FOR THE MEETING OF: April 15, 2021
AGENDA ITEM: 5.a

TO: Historic Landmarks Commission

CASE NO.: Historic Design Review Case No. HIS21-02

APPLICATION SUMMARY: A proposal to construct a new two story house.

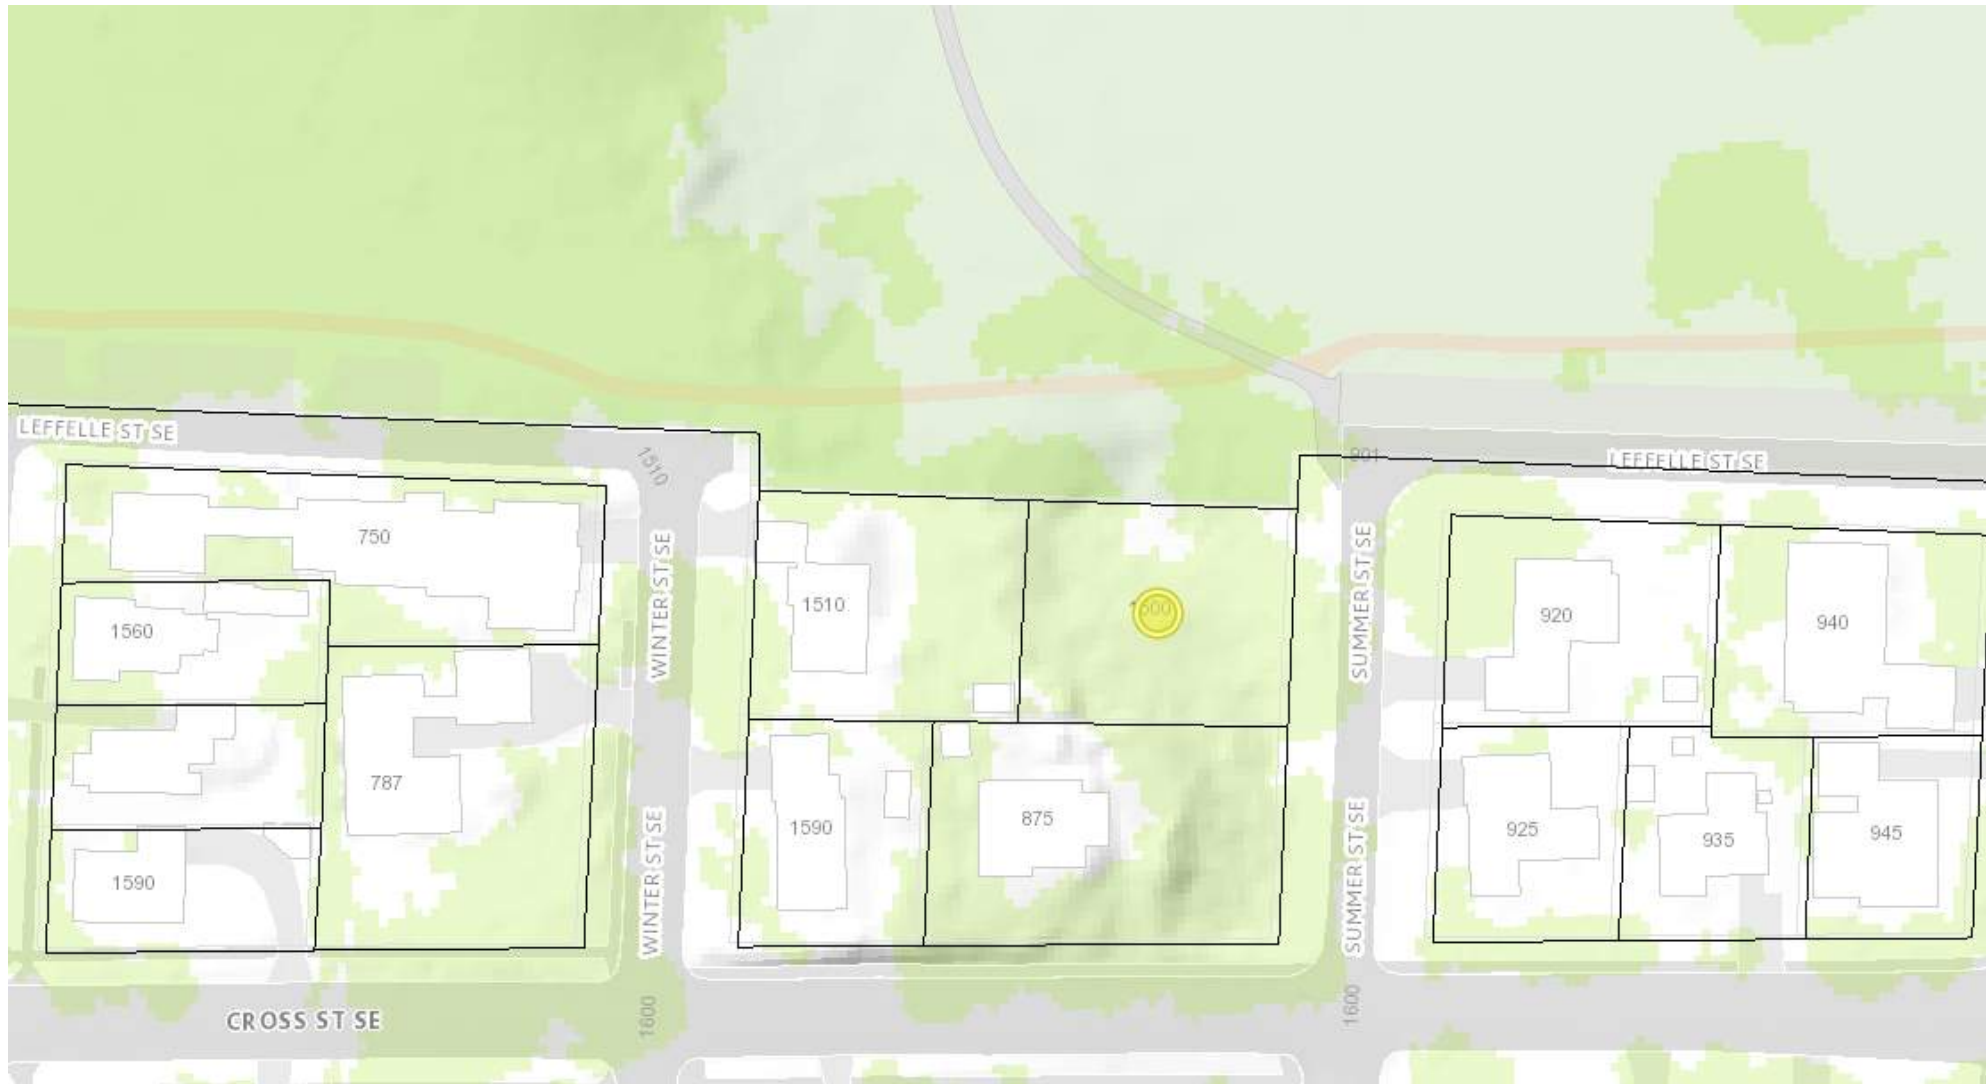
SCAN Comment 2: Unclear regarding the application of SRC 230.075 Streetscape Standards (sidewalks/historic landscape buffer zone/location of public right of way); there is no map showing clearly where the right of way is for Summer Street; Leffelle and Bush's Pasture Park (property boundary).

The application for Design Review does not include a map or information to show where the public right-of-way for Summer Street, Leffelle Street and Bush's Pasture is.

Staff Response: As noted below by Public Works, the proposed development is exempt from constructing City curb and sidewalk pursuant to SRC 803.040; The scope of work is limited to redevelopment of the site within the privately owned lot (Marion County Assessors Map and Tax Lot number: 073W34AB00600) and does not include any work within existing historic sidewalks that would impact the streetscape within the existing Gaiety Hill/Bush's Pasture Park Historic district, therefore SRC.230.075 does not apply to the evaluation of this proposal. See **Attachment A1** for a map showing the Right of Ways for streets abutting the subject property.

1 PROPOSED SITE PLAN
3/16" = 1'-0" (@22X34)

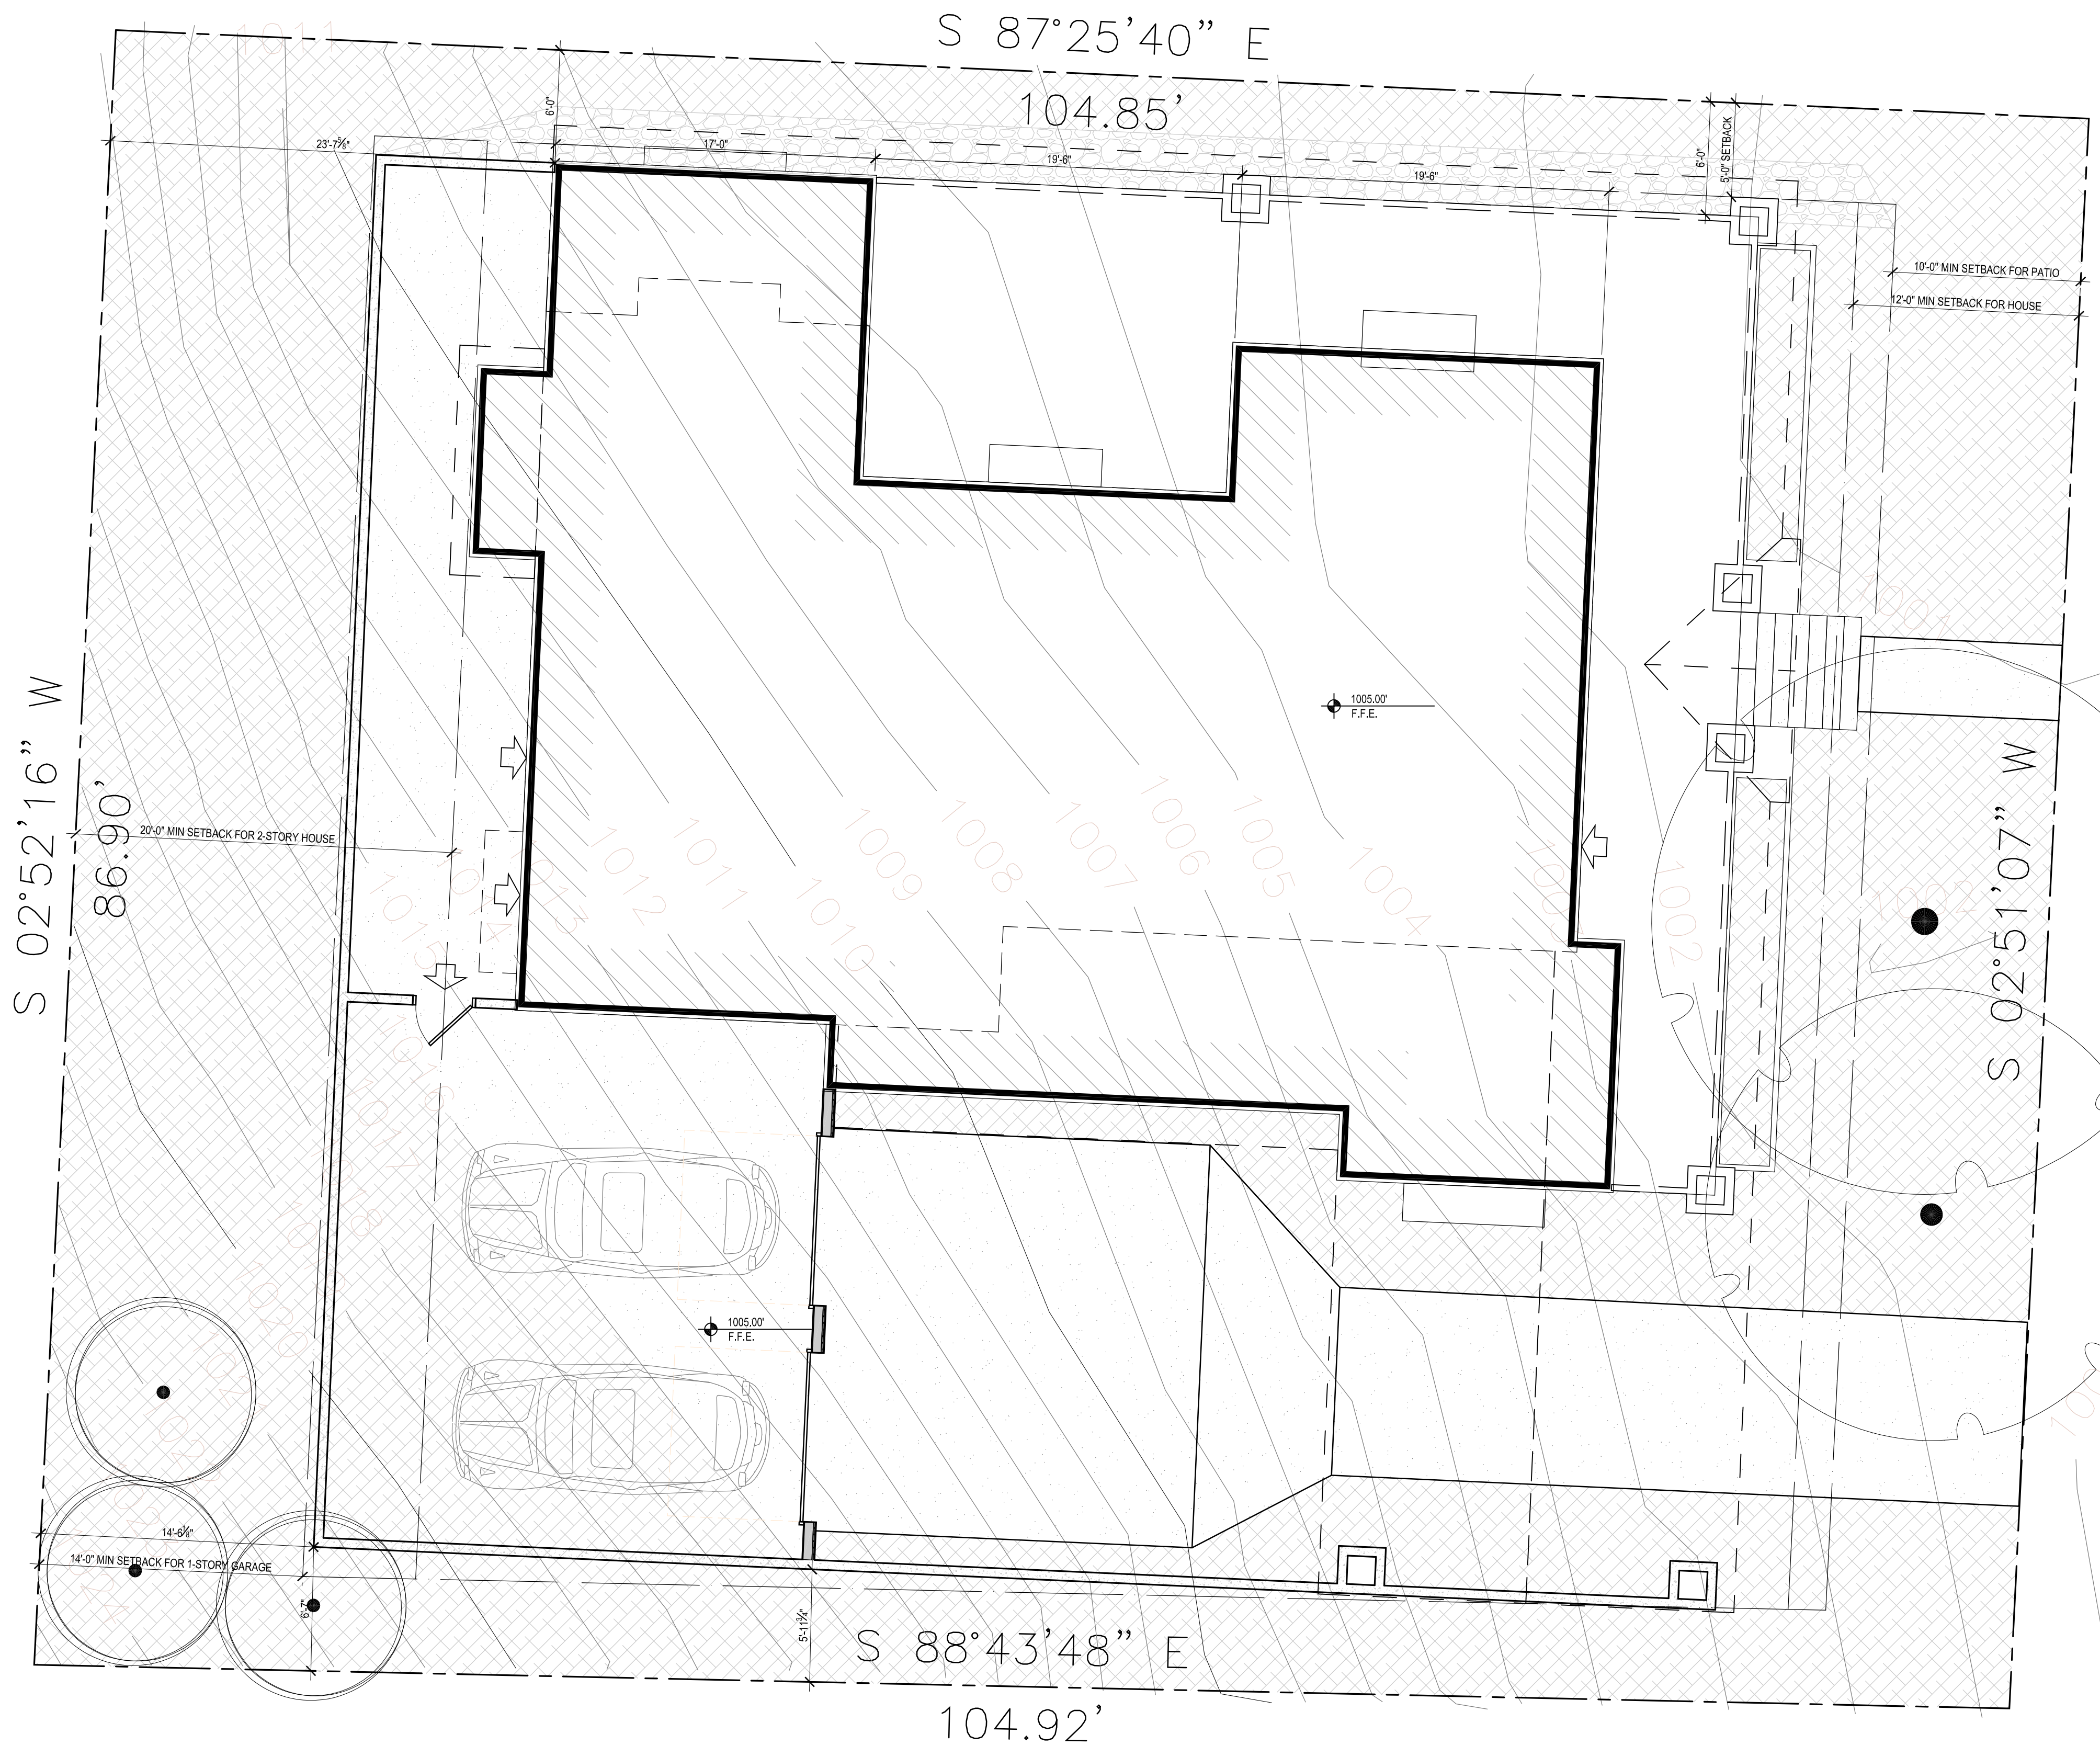
Finding: The applicant has proposed two main retaining walls both of which are proposed at the rear of the property. The southern retaining wall ranges in height from 2' to 12' where it meets the garage. The western retaining wall ranges in height from 4'6" to 11" in height where it meets the garage. In order to better meet this criterion, staff recommends the HLC adopt the following Condition of Approval:

Condition 2: The proposed retaining walls shall be terraced, so that no section of retaining wall exceeds 4' in height.
